VOLUME 2 OF 2 - ZONING

2012 ANNUAL REPORT

Z-003.00

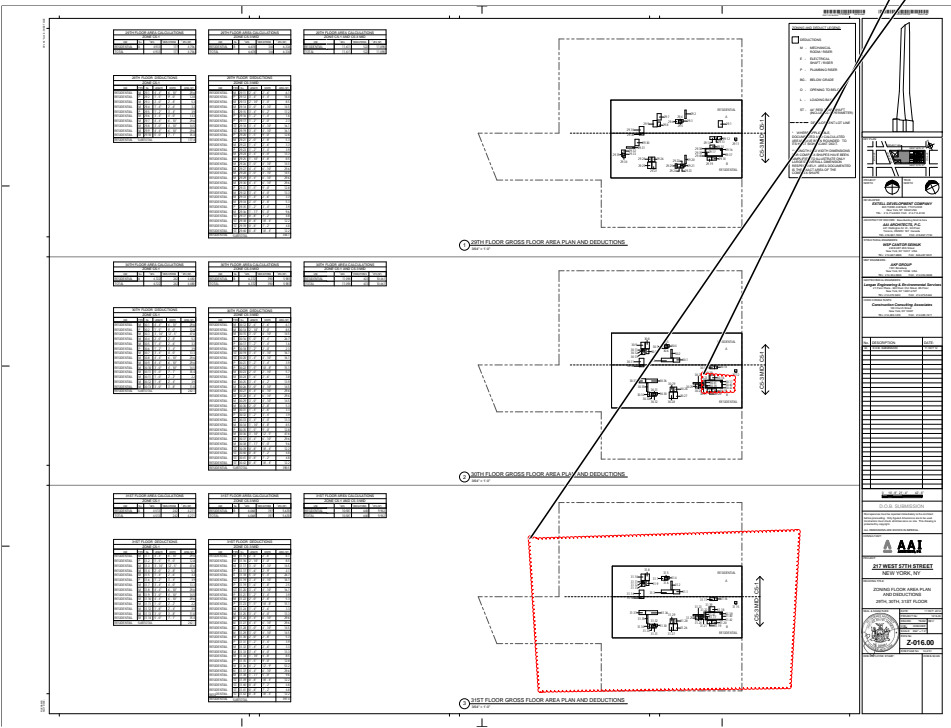
Please clarify deductions taken within stair inclosure. **TYP all floors.**
8" for the stair perimeter, not sure what the additional 60+ sq. ft. is for per floor. ARCH/MH dwgs does not indicate any shaft enclosures within stair.

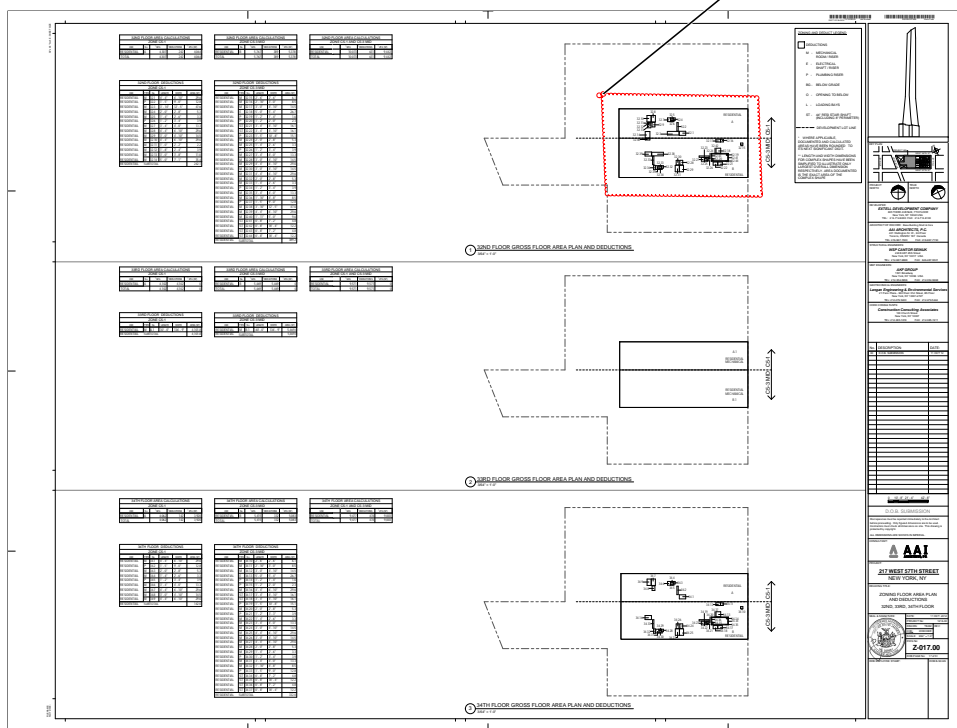
Mech. plan was not provided for this floor. 31st FL.

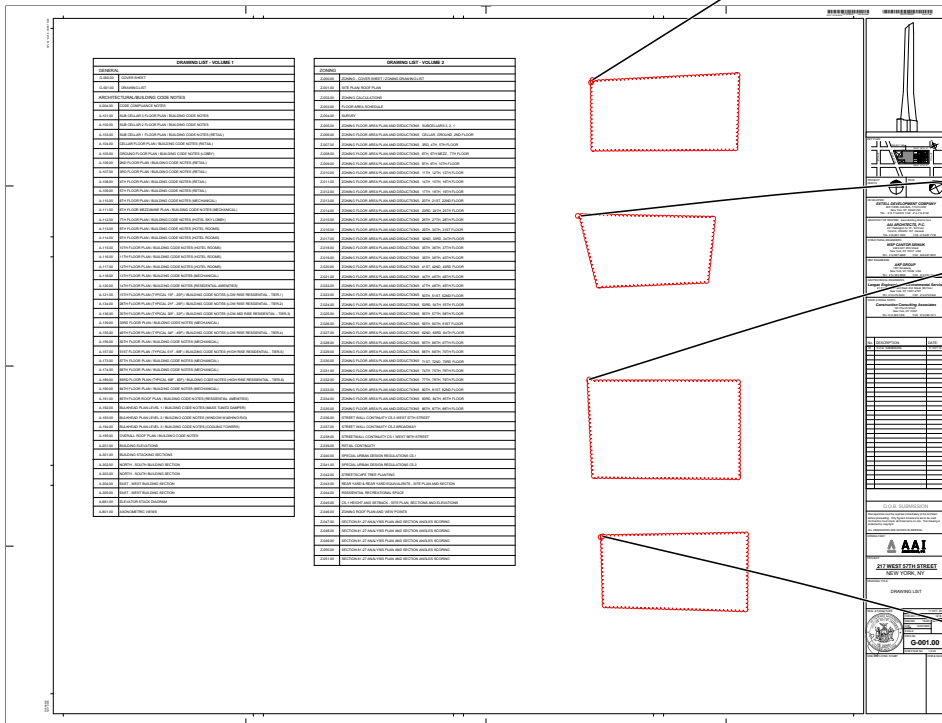
Supporting documentation: building wall sections fail to detail insulation as continuous and/or cavity insulation to match the location and R value in the energy analysis.

Supporting documentation: door, window and skylight schedules fail to provide columns for u values for each exterior door, window and skylight type. If door, window and skylight types are drawn instead, with specifications included next to the respective drawing, u and SHGC values must appear with the other performance specifications for clarity and ease of contractor take-offs.

Supporting documentation: heating and cooling systems, including controls, are not provided such that they match the systems, equipment and performance criteria in the energy analysis.

Supporting documentation: plans fail to include reflected ceiling plans or lighting layouts on floor plans with fixture types and quantities, lamp wattages and quantities, space areas, sensors and controls to match those in the energy analysis for each room in the building.

Supporting Documentation: Building wall sections fail to label insulation at the roof/ceiling, wall and/or at the foundation, slab-on grade, basement or cellar with R values matching those in the Energy Analysis.

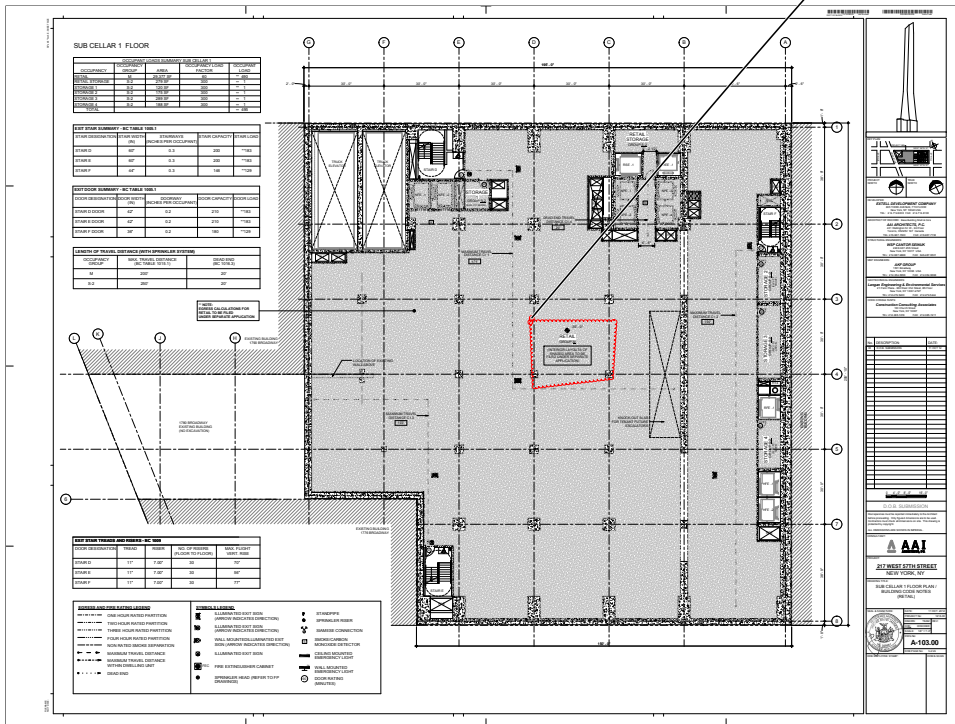
TABLE 403.1 Provide table for plumbing fixtures to comply with table 403.1. Provide calculations within each space, etc. and show layout to verify compliance to BC 1101.2; ICC/ANSI A117.1-2003

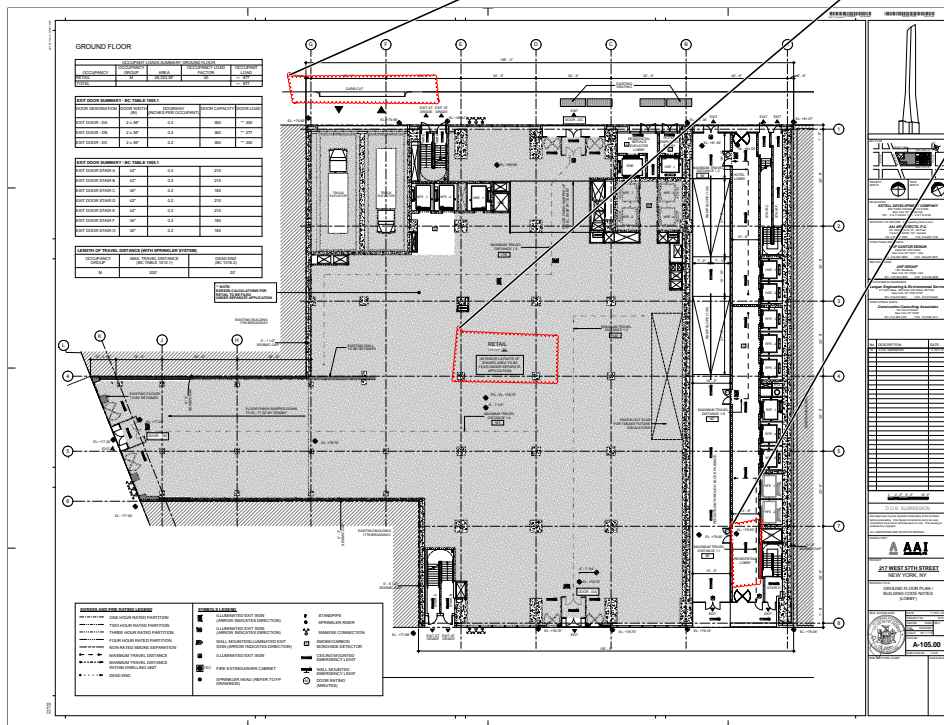
en Location of proposed curb cut is contrary to section BC 406.7.6 (3). This is not a corner lot and a minimum separation of 8'-0" is required from side lot line.

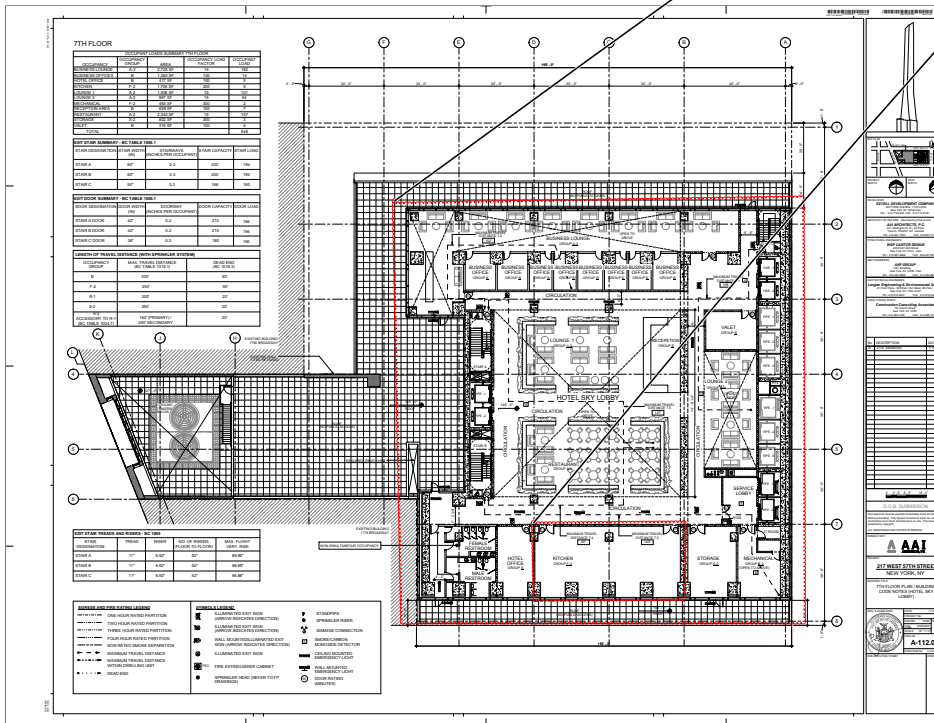
BC 903.2.12.2 Commercial cooking operations. An automatic sprinkler system shall not be installed in a commercial kitchen exhaust hood and duct system. Fire extinguishing systems shall be installed in commercial cooking systems in accordance with Section 904.11.

BC 904.2.1 Hood system suppression. Each required commercial kitchen exhaust hood and duct system required by the *New York City Fire Code* or the *New York City Mechanical Code* to have a Type I hood shall be protected with an approved automatic fire-extinguishing system installed in accordance with this code.

Kitchen shall also comply with MC 506, 507, and 508; PC 802.1.7 and 1003.3.1. Please verify on MH/PL plans.

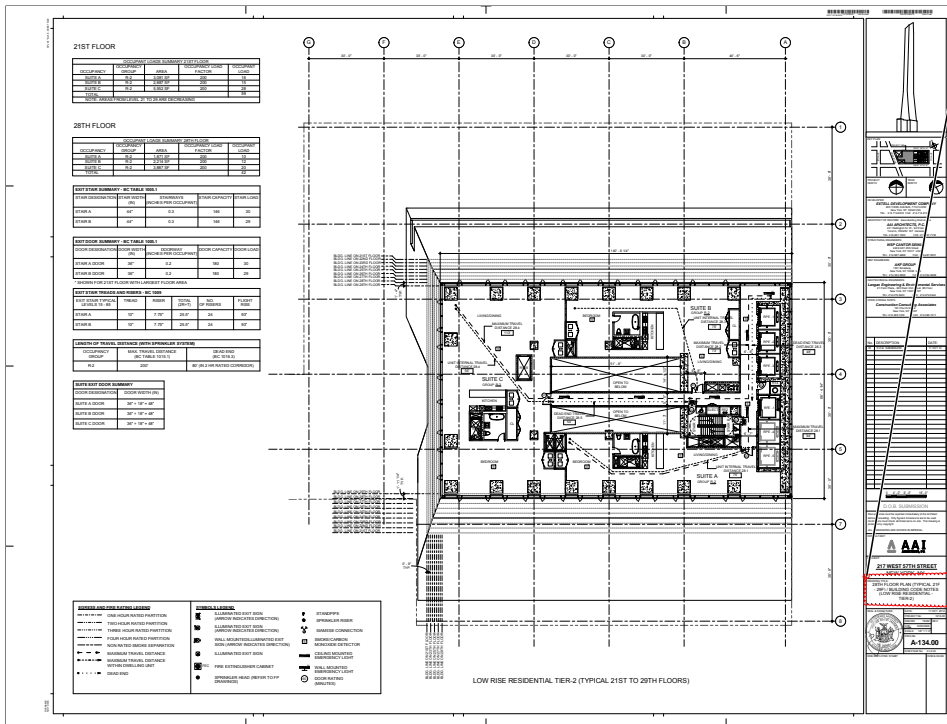
Author: dtitus Subject: Polygon Date: 1/7/2013 9:31:18 AM
The common path of egress travel shall not exceed 125 feet as per BC 1013.3. The maximum length of exit access travel, measured from the most remote point within a story/space to the entrance to an exit along the natural and unobstructed path of egress travel, shall not exceed the distances given in BC Table 1015.1.

Author: dtitus Subject: Polygon Date: 1/7/2013 9:30:14 AM
BC 908.7.1.2 Provide notes to indicate compliance for carbon monoxide detectors.
Indicate location of smoke/ carbon monoxide detectors. (TYP.)

Author: dtitus Subject: Polygon Date: 1/4/2013 10:06:27 AM
Provide refuse chute details: [2 hr fr walls & roof] and compliance with BC 1213.3 and BC 707.13
Refuse storage room to comply with BC 1213.1
Provide proper enclosure and details
Provide UL # for system or fire hopper doors
Compliance with BC 1101.2;

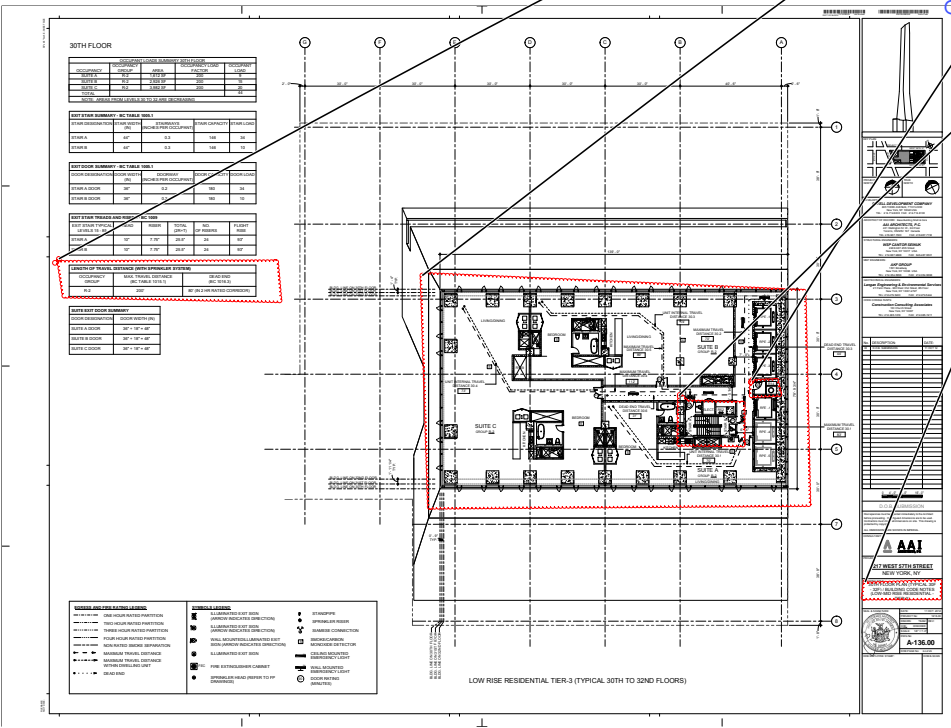
Author: dtitus Subject: Polygon Date: 1/4/2013 10:05:14 AM
Please indicate as Typ. 30-32nd Floor Plans

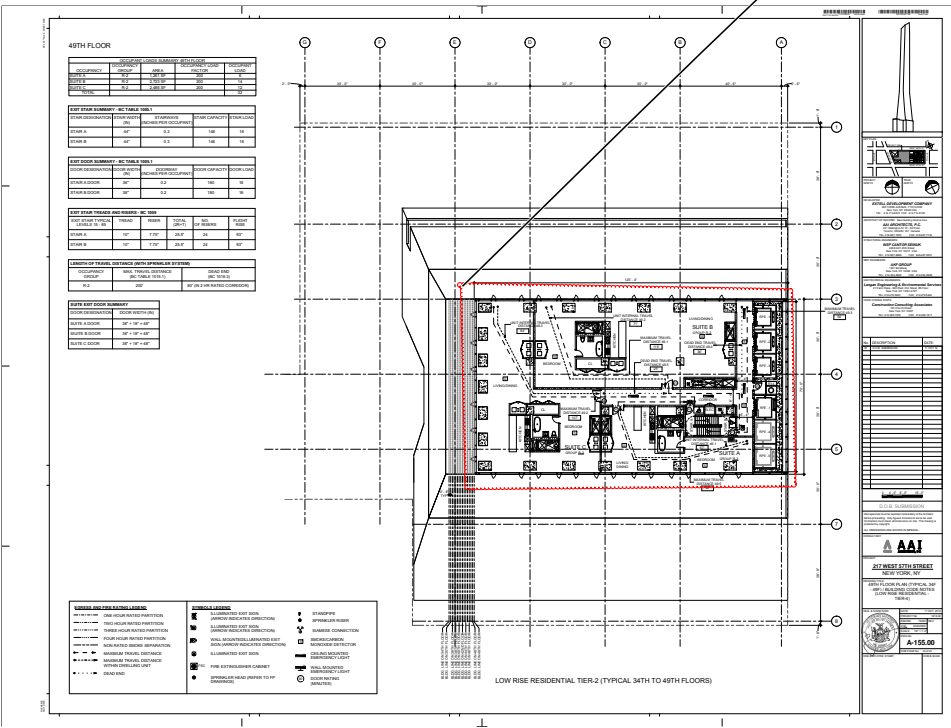
BC 1101.1, 1101.2, and
ICC/ANSI A117.1-2003 Verify compliance with accessibility as per BC 1101
Primary access- 1105
Doors & maneuvering clearances-1107.2.1
Residential bathrooms – 1107/ Appendix P
Residential kitchens – 1107.
Show all grab-bars including vertical as per P102.8.3.1,
Walk-in closets
Access to W/D within units
TYP. all R-2 floors

Provide fire protection of openings in exterior walls (BC 704.8, BC 705.8, BC 715.4).

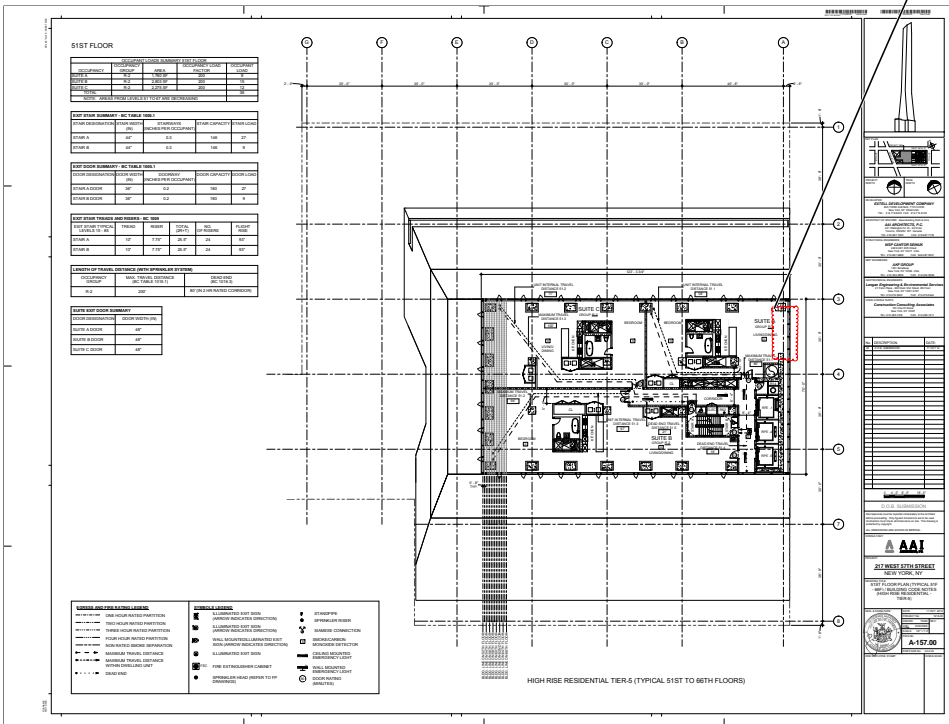
note required on elevation dwg. to indicate
1 hr rated wall.

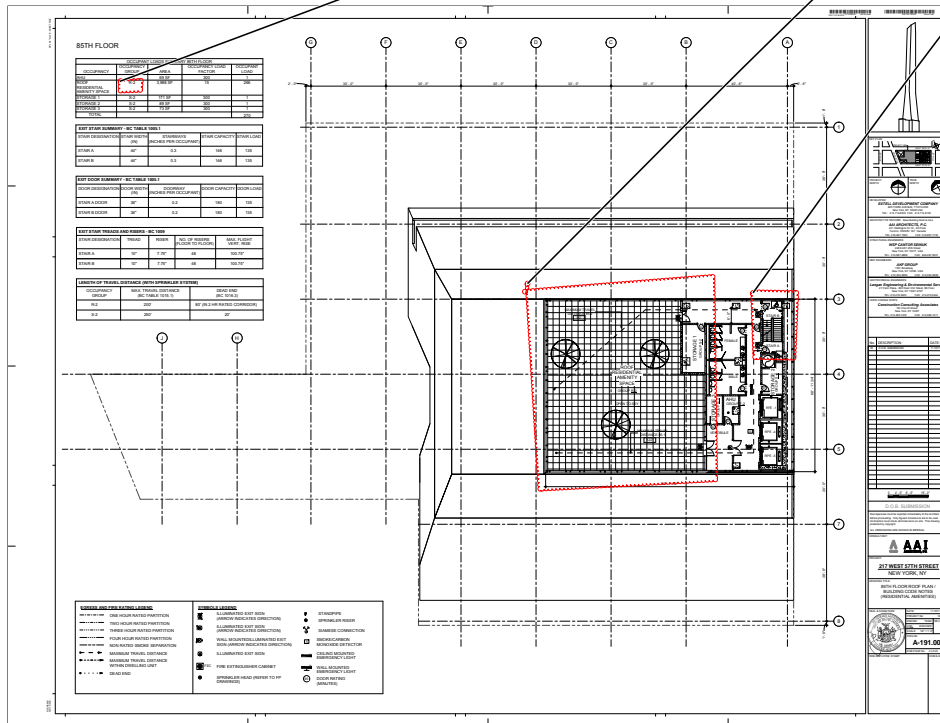
All interior stairs must lead to the roof as per BC 1009.12

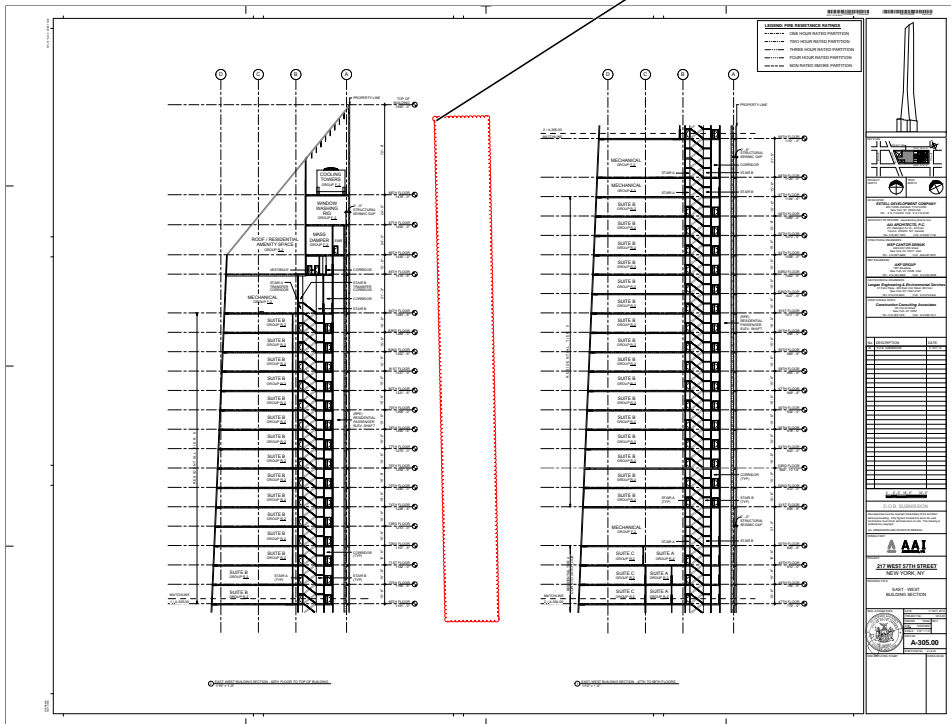
Provide all schedules windows, doors (indicate FPSC on all fire rated doors) etc.

Provide structural peer review report as per BC 1627.

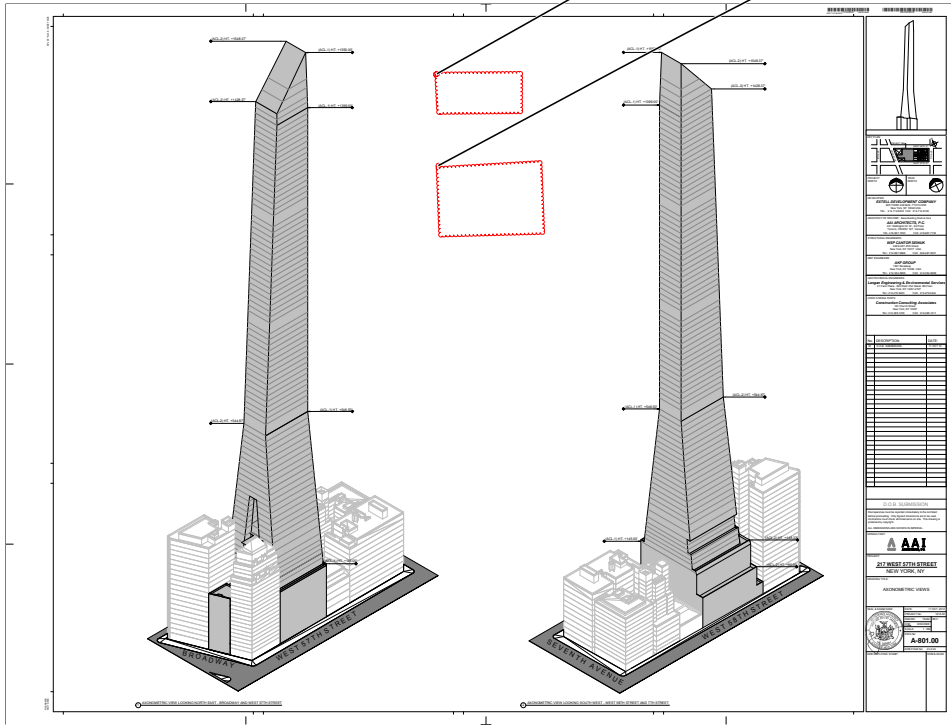
Provide building elements, exterior walls of non-combustible construction with fire-resistance ratings for Type I-B construction (BC 602.1, BC 602.2).
